Natural England's End of Examination Position on Marine Processes

The construction and operation of Hornsea Project Four Offshore Wind Farm, located approximately 69 km from the East Riding of Yorkshire in the Southern North Sea, covering an area of approximately 468 km².

Planning Inspectorate Reference EN010098

Subject: Hornsea Four: Marine Processes Supplementary Report, Doc. Ref. No: G4.9 (Rev 01) [REP4-043]

Figure 1. Comparison of 1979-2020/21 bathymetric survey data (taken from Ørsted, 2022)

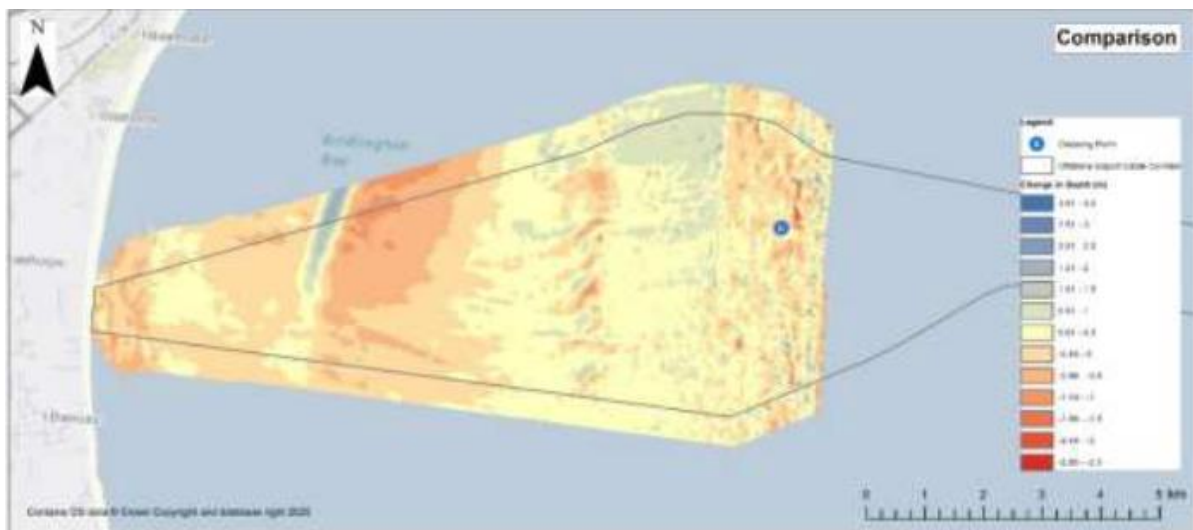
Figure 1 above shows comparison of the 1979 and 2020/21 bathymetric data for the Dogger Bank A & B Cable Crossing. This shows that there is evidence for up to 2.5m bathymetric change at the Dogger Bank A & B Cable Crossing site over the period 1979-2020/21 which raises concerns regarding the potential for morphological change.

Figure 2.

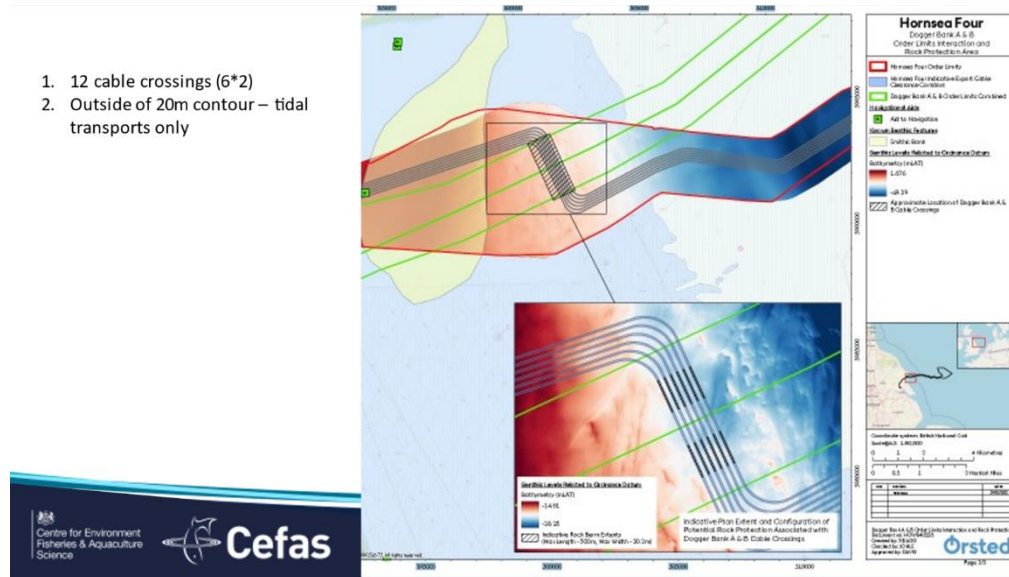
Figure 2 below shows the Hornsea Four/Dogger Bank A & B Order Limits Interaction and rock protection area. The Dogger Bank A & B Cable Crossing includes 12 cable crossings with individual rock berms at each cable crossing that have maximum length and width of approximately 500m by 20.2m, and a berm height of up to 3m. Given the close proximity of the Dogger Bank A & B Cable Crossing to the geomorphological eastern boundary of Smithic Bank, we remain concerned that the presence of these cable protection measures could cause morphological change (e.g. enhanced lowering of the sandbank) through the modification of the hydrodynamic regime or via diversion of sediment transport pathways and, therefore, we advise that the cable crossing be moved as far seawards as possible within the Order Limits. Whilst noting the constraints Ørsted face with regards to moving the cable crossing eastwards due to the Order Limits, Natural England and MMO/Cefas also propose that any reduction in the MDS of cabling and crossings which could be secured before consent would also help limit any impact on the Bank, such as bundling Hornsea 4 cables within fewer trenches and using HVDC

technology to reduce the total number of cables and crossings required. It is also worth noting that Dogger Bank A&B has confirmed that their export cables will be bundled in 2 trenches.

Given the indicative nature of the current Hornsea Four plans showing the location of the Dogger Bank A & B Cable Crossing, we advise that the most up-to-date Dogger Bank A & B cable routing plans should be used to generate more accurate cable crossing plans by the Applicant. In turn, this more up-to-date and accurate plan of the Dogger Bank A & B Cable Crossing will provide a clearer indication of the location of the crossing relative to the eastern geomorphological boundary of Smithic Bank and inform the impact assessment.
